**Atkins**  
**1600 RiverEdge Parkway, NW,**  
**Suite 700**  
**Atlanta, Georgia 30328**  
**January 25, 2019**

**ADDENDUM NO. 1**  
**to the**  
**PLANS AND SPECIFICATIONS FOR THE**  
**PTC 17.05 Advanced Vehicle Lanes Project**  
**Plans and Specifications Dated: 1/25/19**

JOB NO.	100060401
DRAWN	LR
DESIGNED	RFR
CHECKED	JDB
DATE	1/25/19
SHEET	13-15

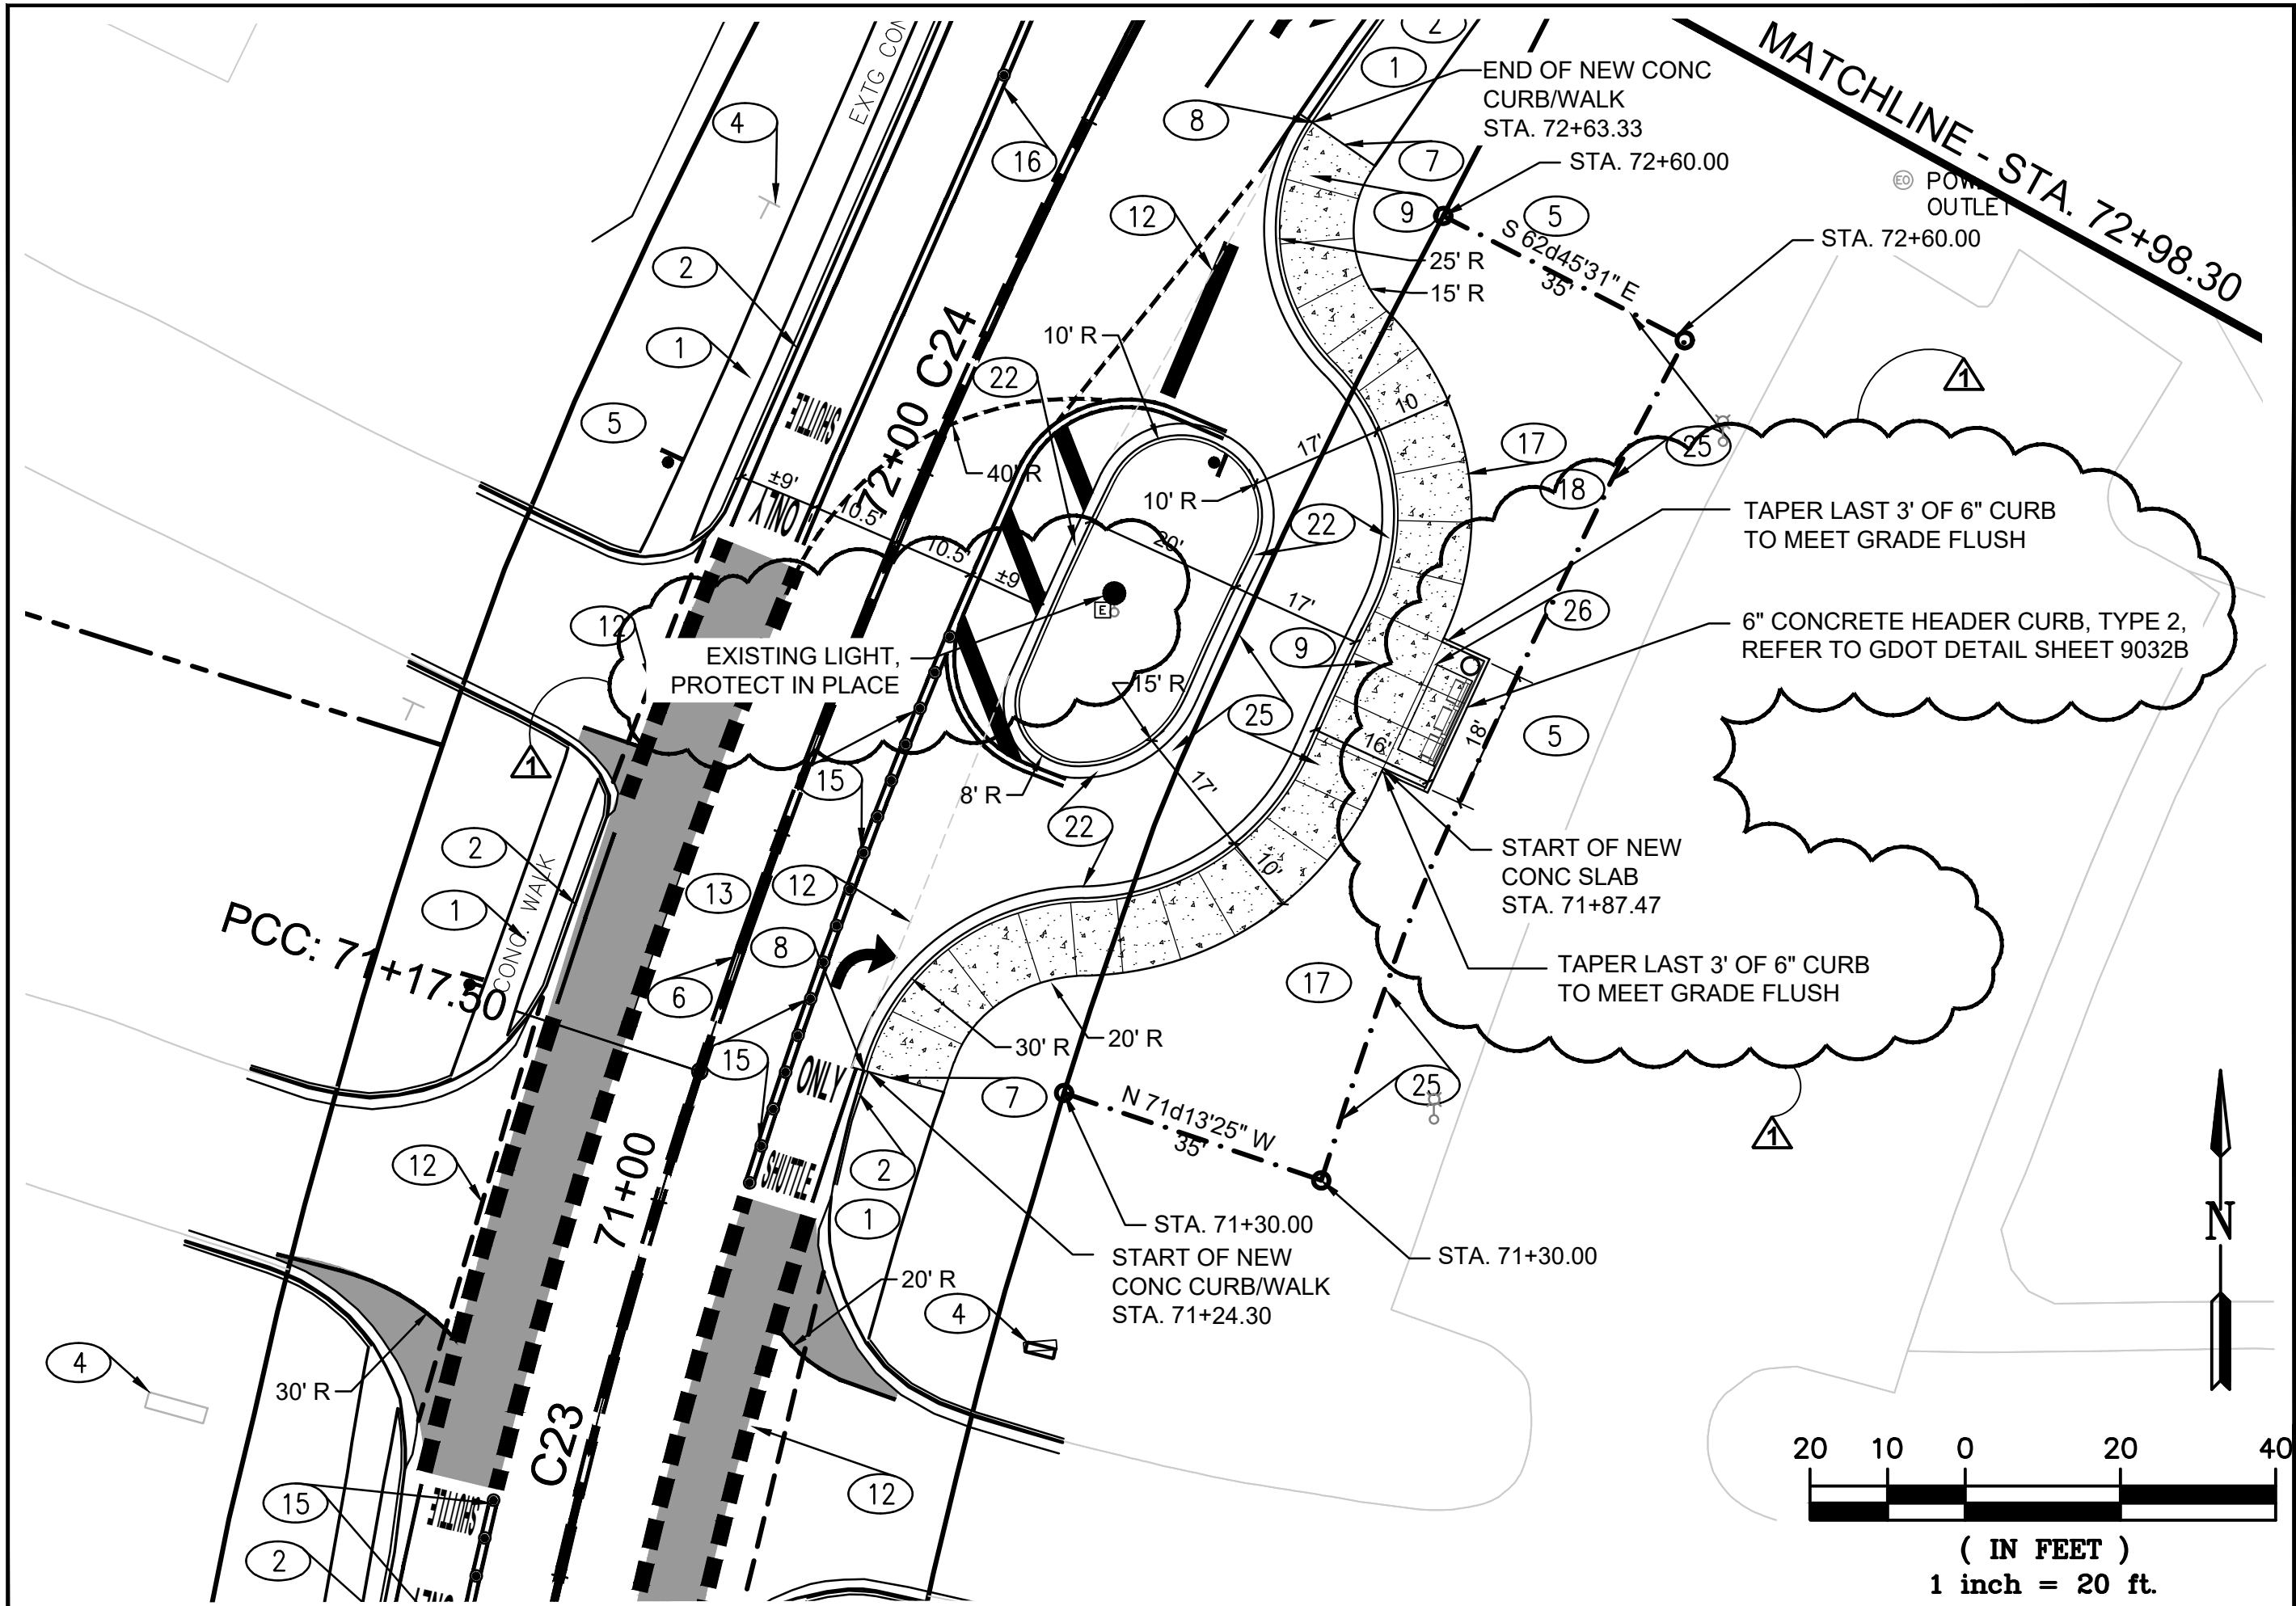
1. Additional grading information for Bid Alternate #1, Advanced Vehicle turnaround on the north end of the project at Station 72+00. Sheets included in this Addendum are Mainline 13-15, Grading and Drainage 18-07, Typical Cross Section 5-02, Cross Sections 23-25.
2. Any question's regarding bids and misunderstandings that may rise from this proposal must be submitted, in writing and directed to Mr. Richard Rohrer, at, richard.rohrer@atkinsglobal.com no later than 4:00 pm on Tuesday, February 5th, 2019.
3. A signed acknowledgment of this addendum must be included with your bid.
